COUNCIL ASSESSMENT REPORT

Panel Reference	2018STH005
DA Number	T2017-051
LGA	Hilltops Council
Proposed Development	Emergency Services Facility for NSW Rural Fire Service involving: <ul style="list-style-type: none"> ▫ Fire control centre and regional office building ▫ Stores shed accommodating storage as well as parking for up to 4 trucks ▫ Hot fire training ground and shelter building ▫ Communications tower (30m high) ▫ Access road and parking area for 46 cars (includes 2 accessible spaces) and 3 trucks ▫ Overflow parking area for approximately 11 cars) ▫ Water tanks (4 in-ground and 2 above ground) ▫ Fire Hydrant assembly with associated booster, pump and 2 storage tanks ▫ Associated earthworks and utility services ▫ Future Fire Brigade Station
Street Address	4559 Burley Griffin Way CUNNINGAR
Applicant/Owner	Darren Hession, Public Works Advisory on behalf of Rural Fire Service
Date of DA lodgement	24 November 2017
Number of Submissions	One

Figure 11 - Figure 8.10-3: Marking of mast, pole and tower

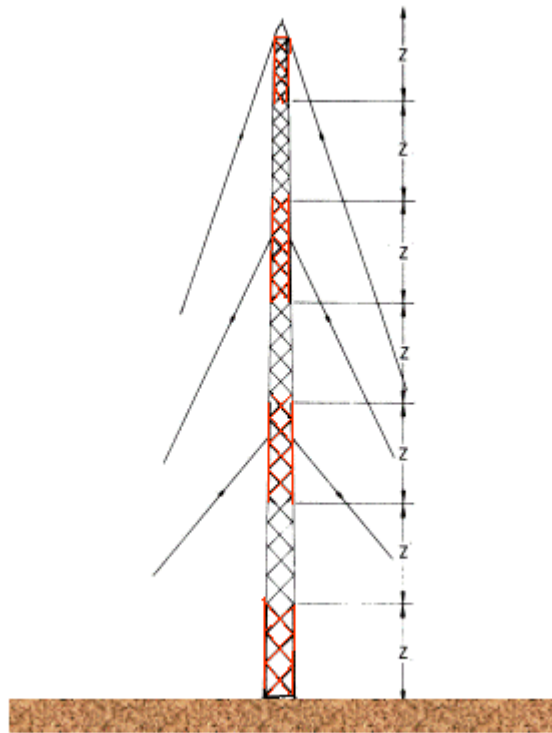
1. Masts, poles and towers must be marked in contrasting bands with the darker colour at the top, as shown in Figure 8.10 3. The bands must be perpendicular to the longest dimension and have a width approximately 1/7 of the longest dimension or 30 m, whichever is less.

Figure 14 - Landscape Plan – extract

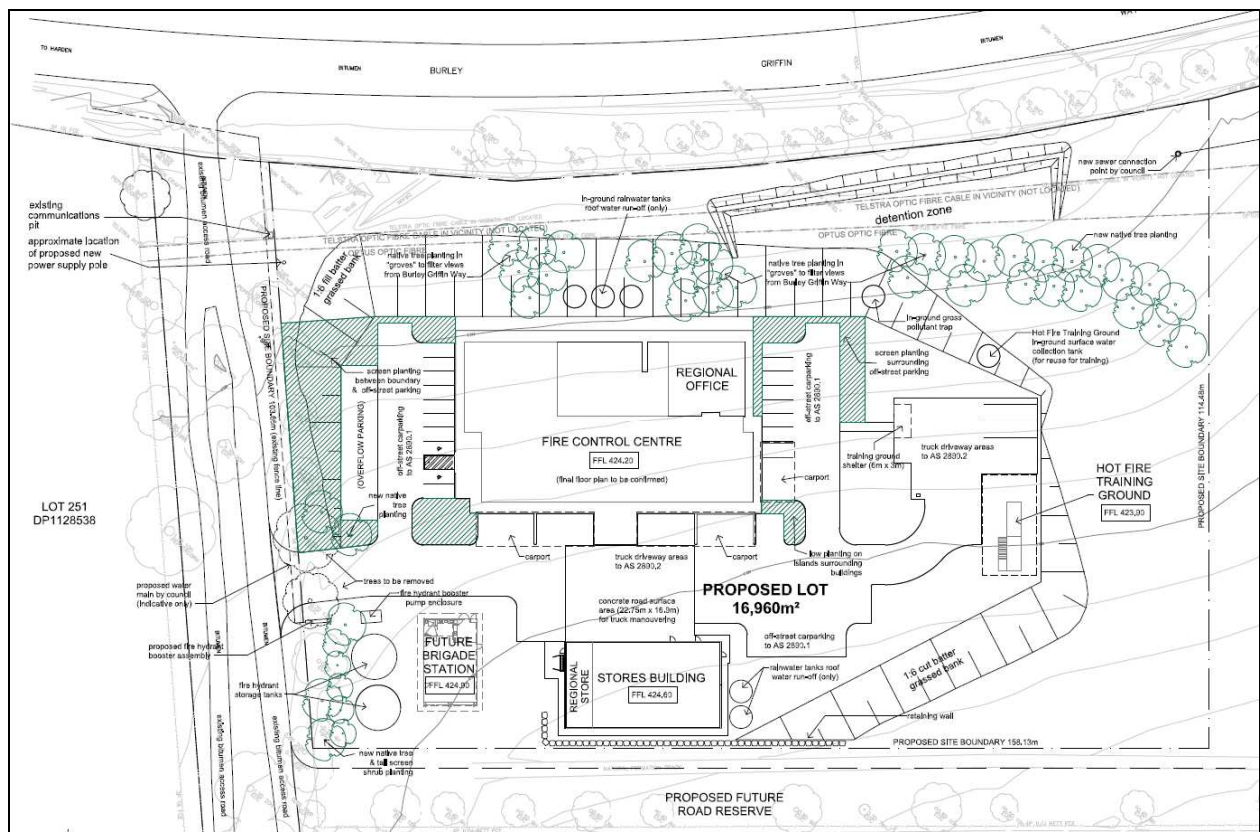
The applicant has prepared a landscape plan (Figures 14 -15) which includes native trees that will grow to heights ranging from 5-25m tall, located along the western edge of the development site adjoining the access road, together with screening trees and shrubs between 2 – 6m tall. Additional screen planning will be required between the proposed driveway and the southern boundary of the development site to ensure an effective landscape treatment for this boundary. There are existing trees through the median of the access road which also provides some screening of the buildings from the dwellings located on Wynwood.

Figure 16 - Extract of Survey plan provided to submitter

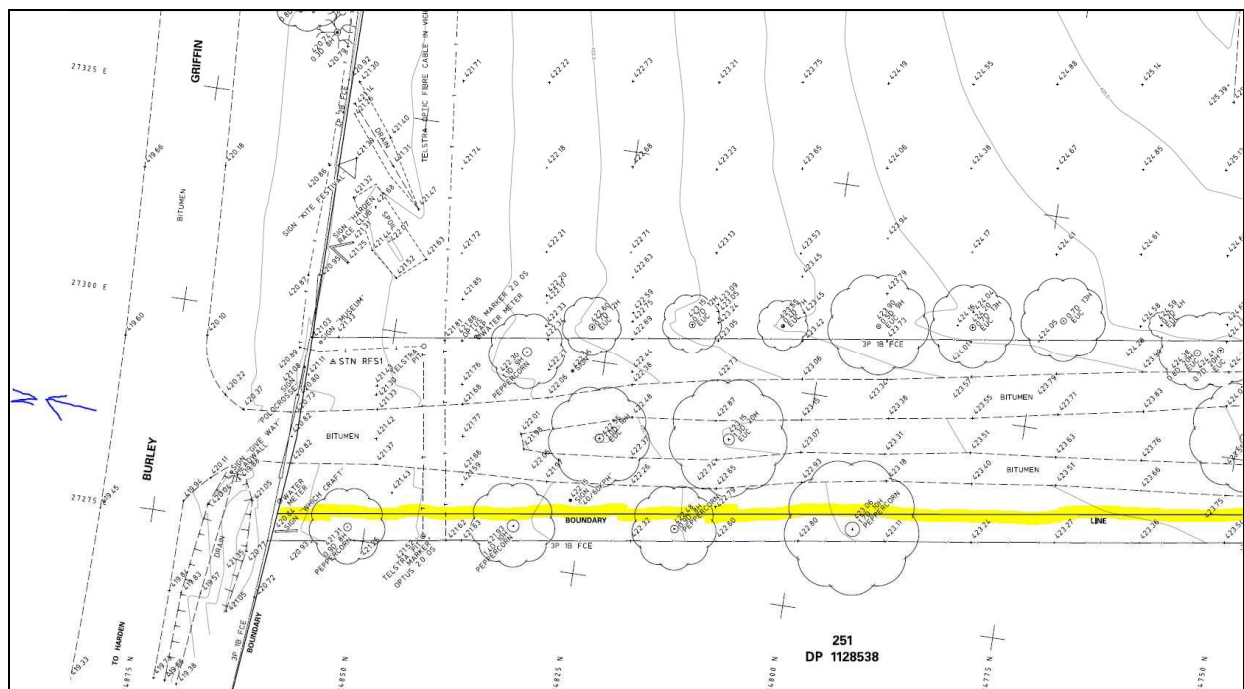
"In reference to your additional request regarding the peppercorn trees, unfortunately, because they are not located on the development site, they cannot be included as part of the development. However, as mentioned on the phone, the survey of the land shows that the fencing of the land is not along the boundary and the peppercorn trees are located within the boundary of Wynwood, not the Racecourse Reserve land. This means that you are able to prune and/or remove the trees to assist with access to the fenceline. I have attached an extract of the survey plan with the boundary highlighted in yellow for your reference."

Figure 8.10-3: Marking of mast, pole and tower

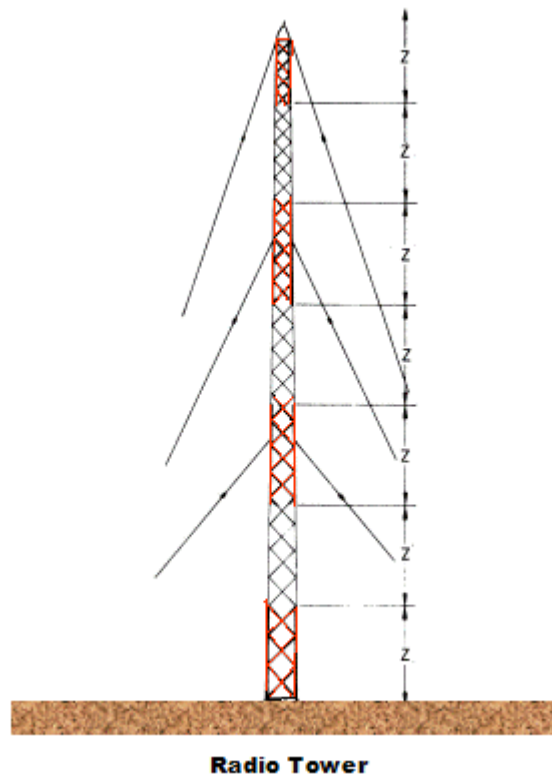
The communications tower must be marked in contrasting bands with the darker colour at the top, as shown in Figure 8.10 3, from Section 8.10: Obstacle Markings of the *CASA Manual of Standards Part 139 – Aerodromes*. The bands must be perpendicular to the longest dimension and have a width approximately 1/7 of the longest dimension or 30 m, whichever is less.
